Section 8.00 & 9.00 comprises point-by-point responses to both the Pre-Application Advice provided by MSDC dated 17th November’23 ref: DM/23/1480 and advice provided by Place Services dated 12th November ’25 ref. DM/25/0133. In addition, responses to the Conservation Officer comments raised on 5th June 2026 are also included in this section.

SECTION 8.00-9.00 Planning Pre-App’s DM/23/1480 & DM/25/0133

Responses to and Comparables with Current Full Planning/Listed Building Consent Applications
(including response to Conservation Officer Comments 05.06.26)

9.03 Place Services Consultation: Areas 1 - 6 (to be read with summary 9.04)

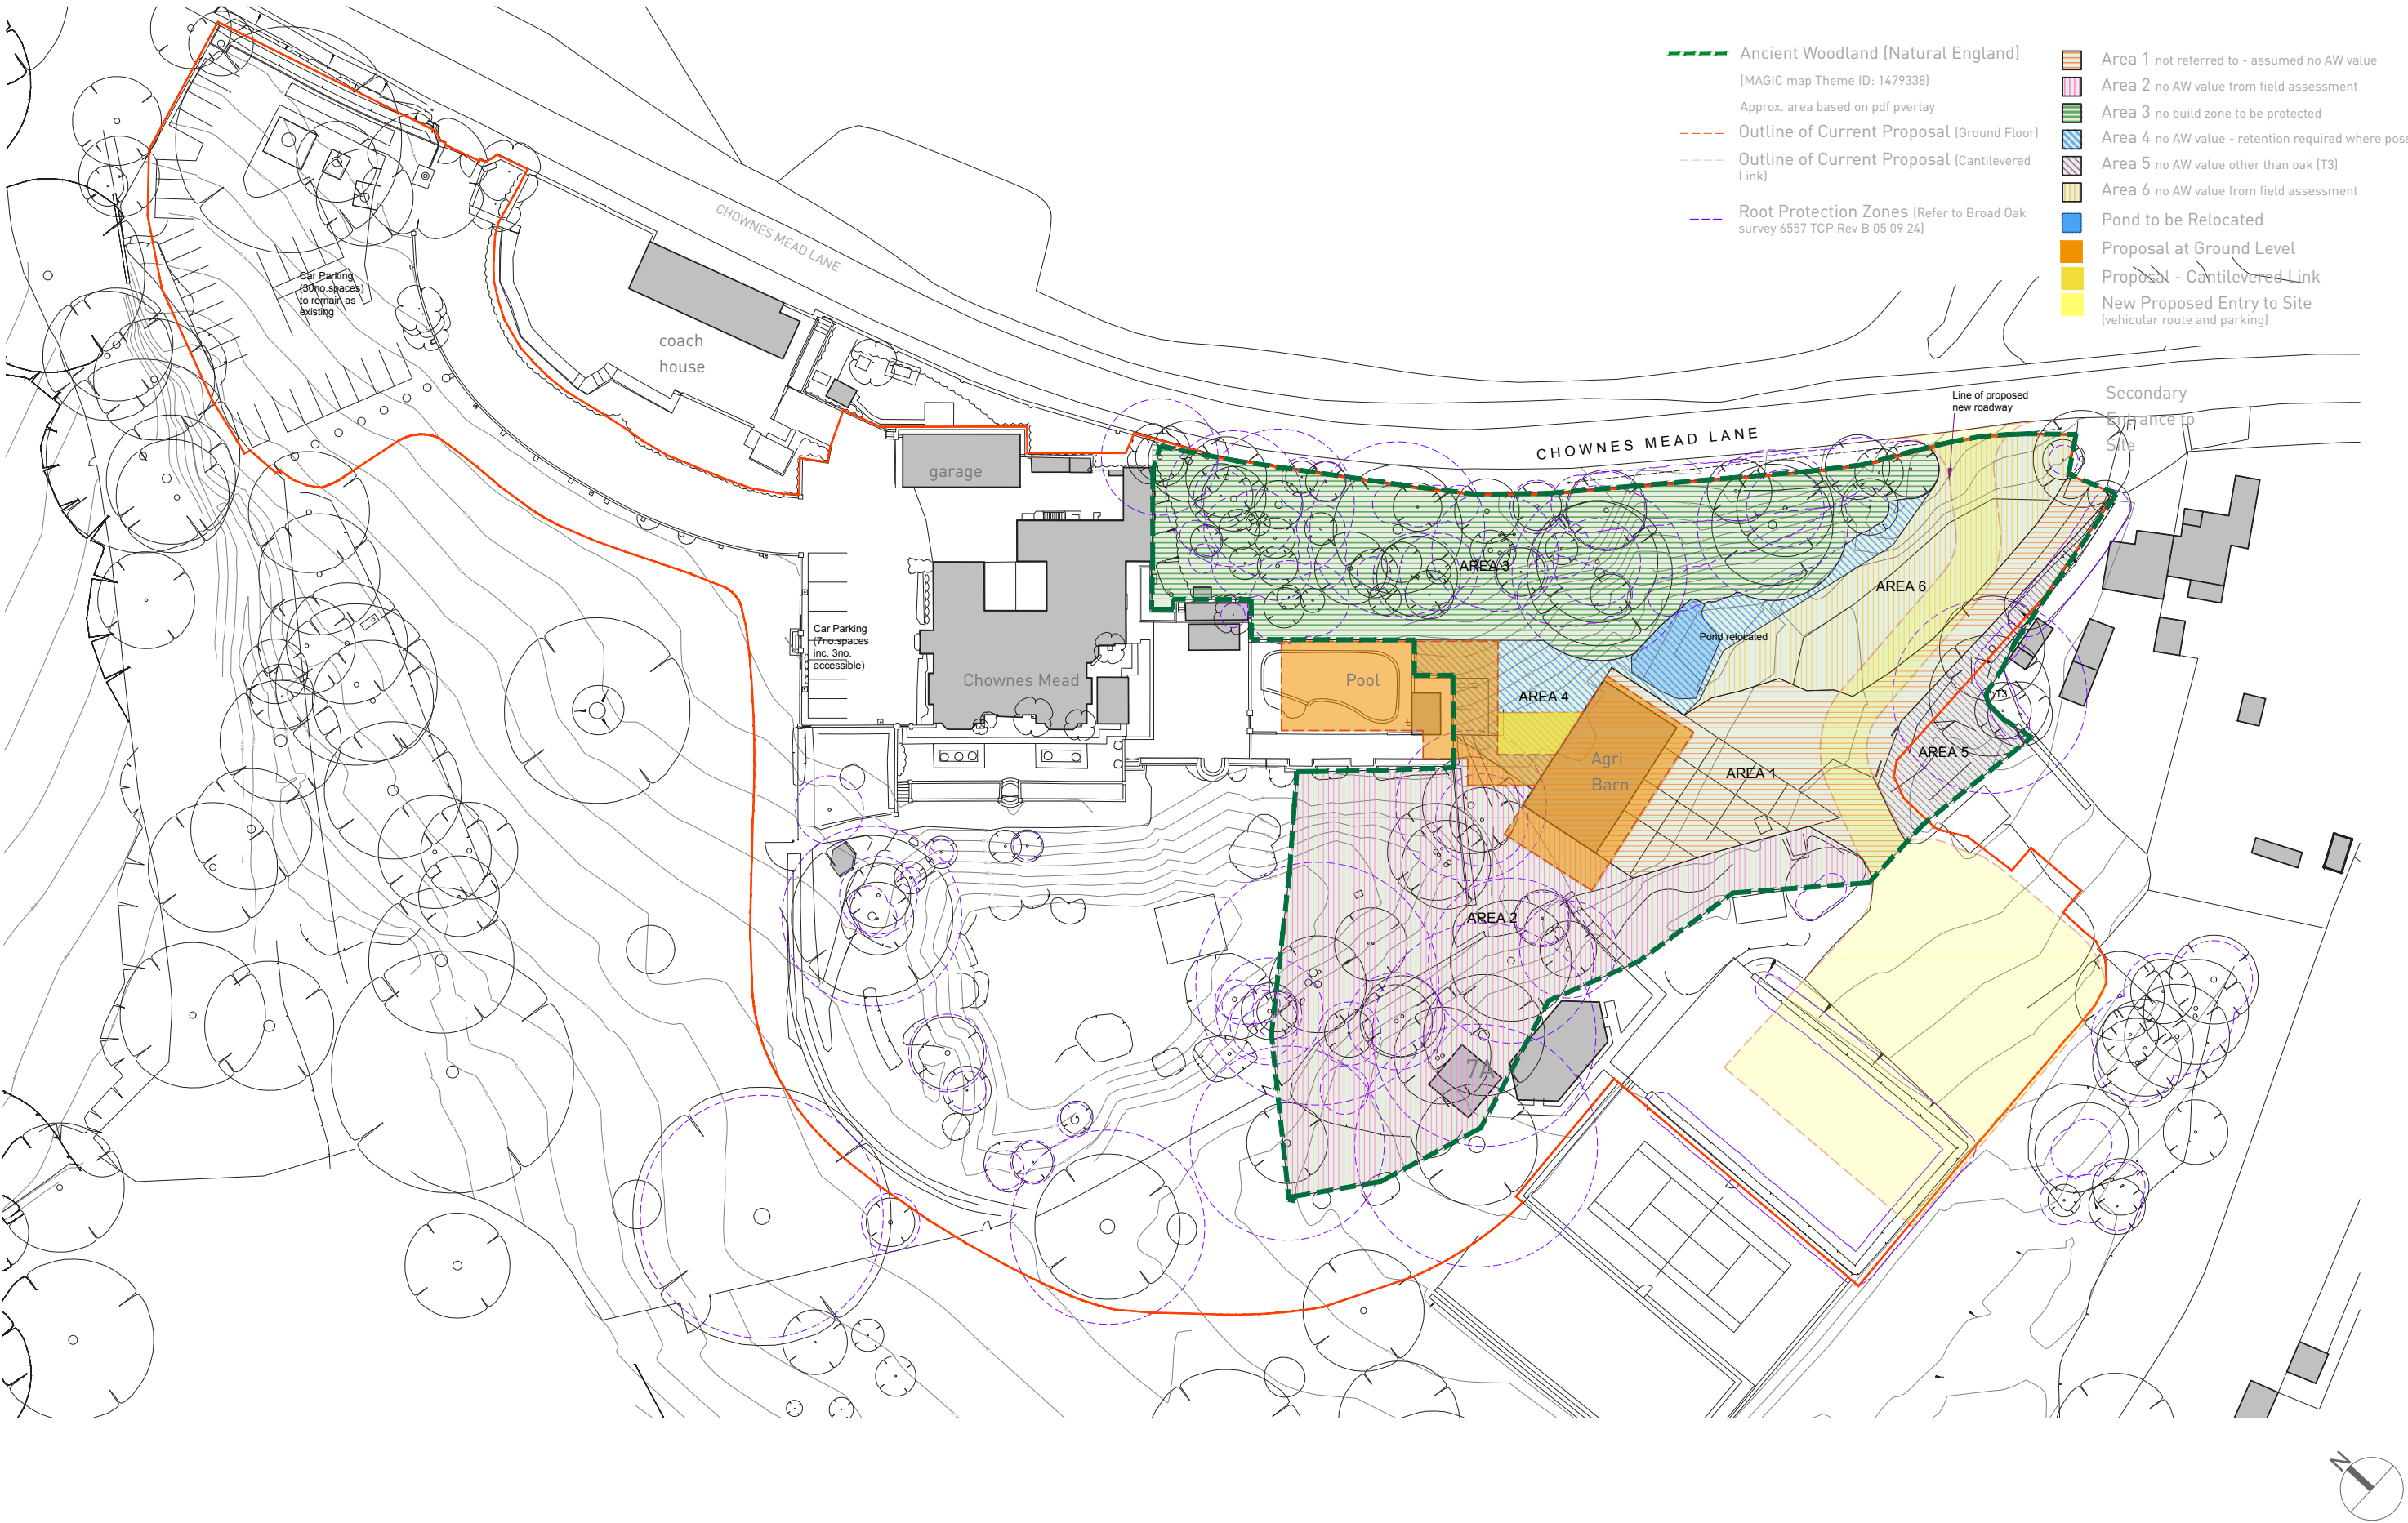
Based on the site visit carried on the 1st May 2025, it is acknowledged that the majority of the site is no longer functioning as Ancient Woodland, with most of the site classified as ‘developed land; sealed surface’. As a result, a pragmatic approach is required for any subsequent application to demonstrate compliance under the NPPF 2024, following the previous loss of irreplaceable habitat permitted as part of historic planning applications. (1)

The area referenced as location 4 in the ‘Assessment of Ancient Woodland’ was adjacent to a pond and dominated by Pendulous sedge, Rhododendron, Willow sp. and Bramble agg. Therefore, it is highlighted that Pendulous sedge is another ancient woodland indicator, where the species have clearly not been planted. Therefore, if this species were not planted, there is a possibility that the ground flora does indicates remnant woodland habitat. Nevertheless, given the pond in close proximity, we do not consider that this is strong indicator species. As a result, it is not considered reasonable that this area should be classified as ancient woodland, following the permitted clearance works. However, the pond and surrounding habitat should be retained as much as possible within the proposed designs.(4)

It is also agreed that location 5 referenced within the ‘Assessment of Ancient Woodland’ consists of a single Oak tree beside a Cherry laurel hedge. It is not clear when this Cherry laurel hedgerow was planted, but the only remnant of the ancient woodland is the Oak tree, with no ancient woodland indicator species. (5)

As a result, the planning application submission will need to demonstrate how further direct and in direct impacts will be avoided on the remaining woodland area (location 3). This could be included within the finalised Ecological Impact Assessment and should be in line with Government standing advice: Ancient woodland, ancient trees and veteran trees: advice for making planning decisions - GOV.UK. (7)

However, given the extent of the remnant woodland remaining, it is not considered that a buffer zone of 15m will be reasonable and instead the applicant should demonstrate that root protection areas will be protected as part of an Arboricultural Impact Assessment in line with British Standard BS 5837 ‘Trees in relation to demolition, design and development’. The finalised proposals will then be outlined as part of a Construction Environmental Management Plan, to be secured as a pre-commencement condition of any consent. The development should be designed around retaining the remaining remnant ancient woodland and the design should evidence that the natural buffers are provided around this habitat are retained / enhanced where possible. Furthermore, invasive species should be removed to minimise potential encroachment to the ancient woodland and other local woodland habitats. It is also understood that there may be an intention to amend the access of the site to the Pool House. Therefore, at an ecological perspective, the access should be retained in the first instance. However, if this is considered a necessary element as part of the proposals, this should ideally be undertaken without removal of the existing trees, along with evidence that the remnant woodland will be protected and buffered. (8)

All responses to the Place Services report should be read in conjunction with areas 1-6 highlighted on plan on previous pages and as identified in the Assessment of Ancient Woodland prepared by Lizard Landscape Design and Ecology (ref. LLD3233/Rev 01, 6th January ‘25).

10.03 Listed Building - First Floor Plan - Overview of Amendments - Response to Conservation Officers Comments 05.06.26 (pages 68-74)

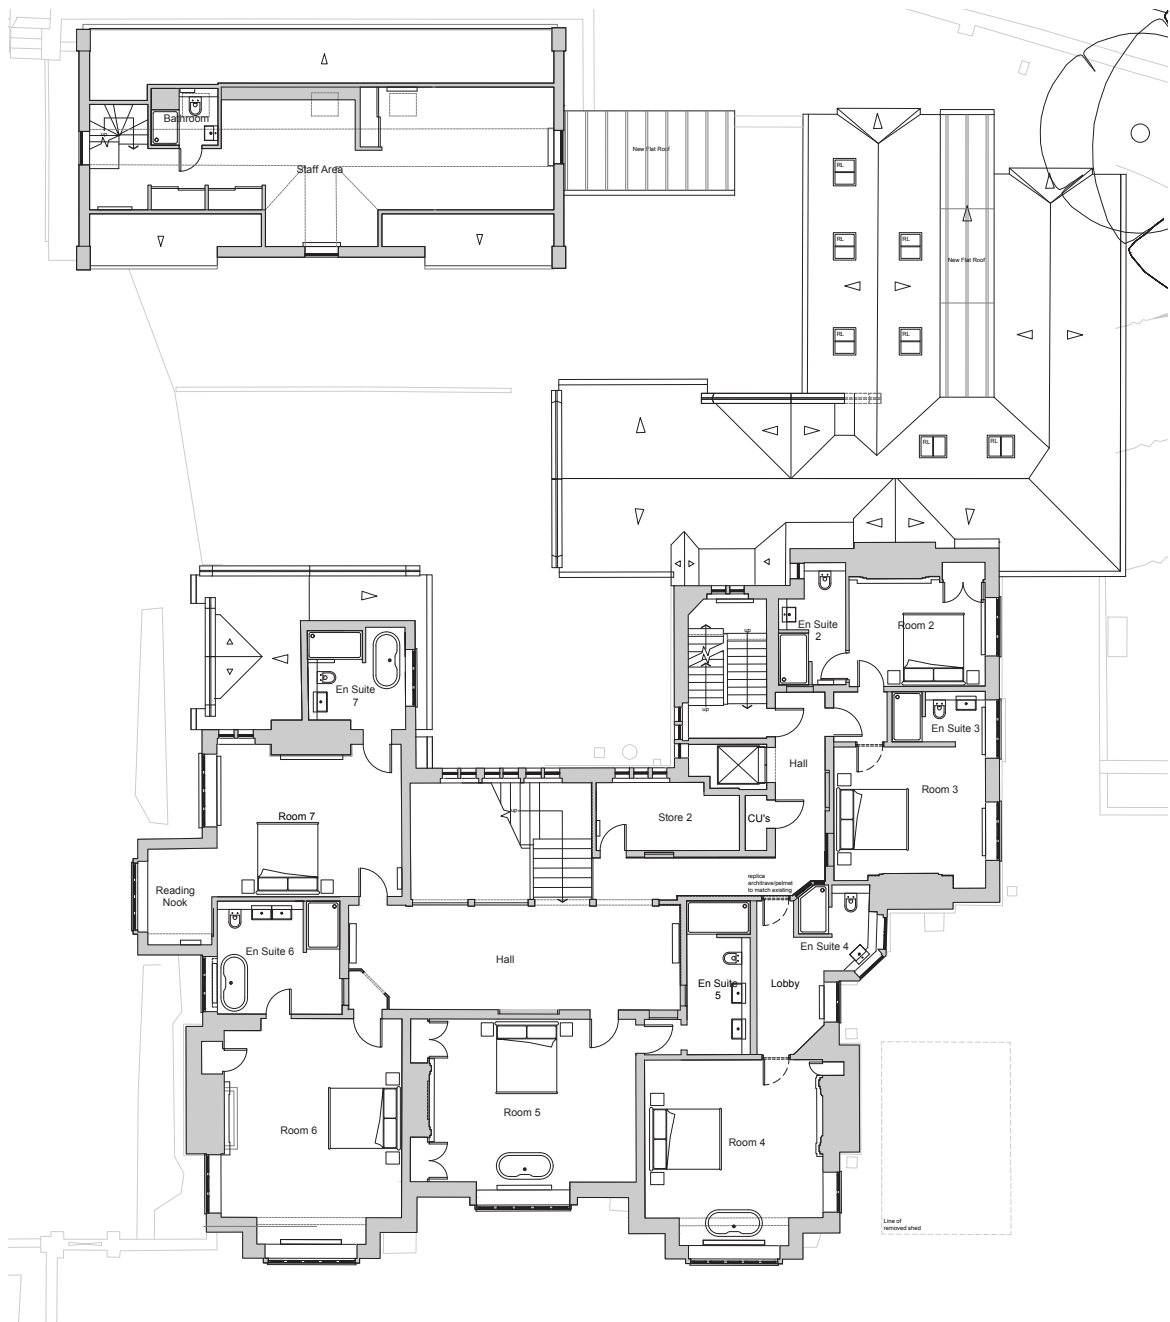
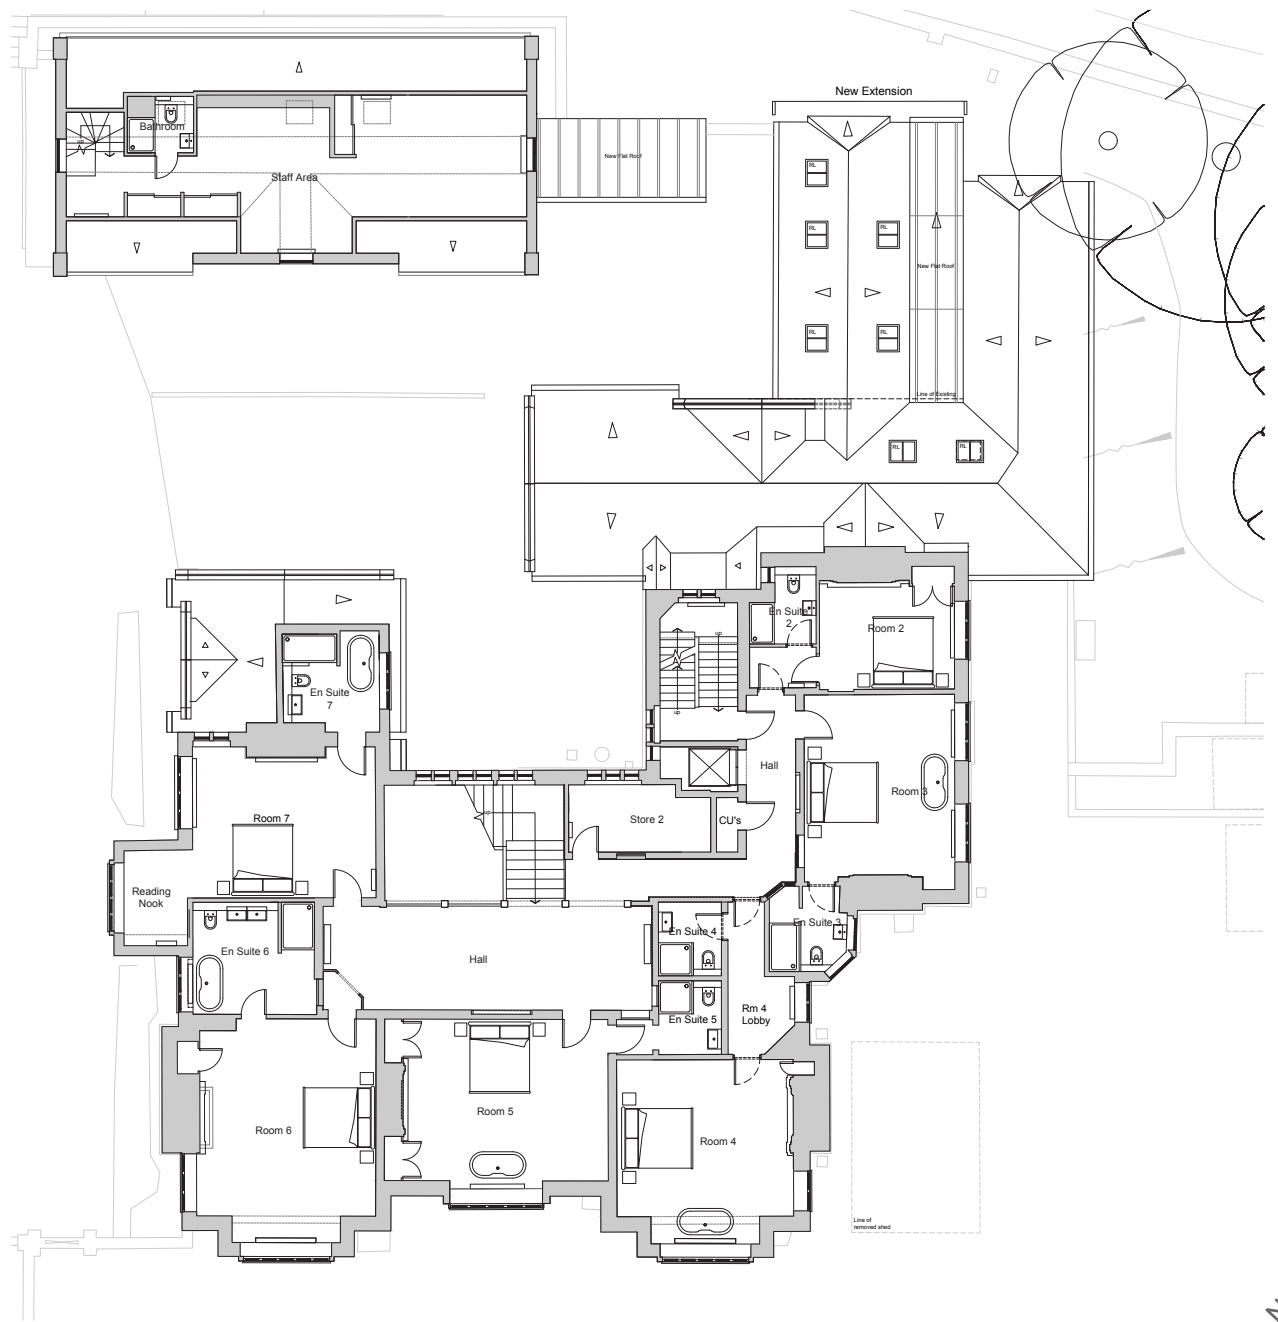
Following comments from the MSDC Conservation Officer, steps have been taken to re-work and improve the floor plan in order to considerably reduce any perceived impact on the listed building as follows -

Proposed bedroom 2 - Existing door (currently locked shut) into bedroom to be re-used from hallway. En-suite arrangement reduced in size to allow for lobby into bedroom 2 (this arrangement replicates the extant permission). Door between bedroom 2 and bedroom 3 will be locked shut retaining original detail and features.

Proposed bedroom 3 - Ensuite and lobby into bedroom 2 no longer proposed - Room 3 will remain as existing with both windows remaining clear of any obstruction. New door opening to be formed to provide access into existing en suite (originally serving bedroom 4 as existing).

Proposed bedroom 4 - Access to bedroom 4 is formed in hallway leading through lobby which is part of the existing dressing room. The room has skirting and cornices which are non-ornate and relatively simple in profile. This would appear to align with the hierarchy of the room (being a secondary / tertiary space) which is of service provision only. Works to the room comprise forming new en-suites to bedrooms 3 and 4 with the partitions scribed around the skirting and cornice to ensure these features are retained in-perpetuity. Where existing partitions are removed skirting and cornices are to be set aside for re-use to new partitions. Existing Doors also re-used in new openings where formed.
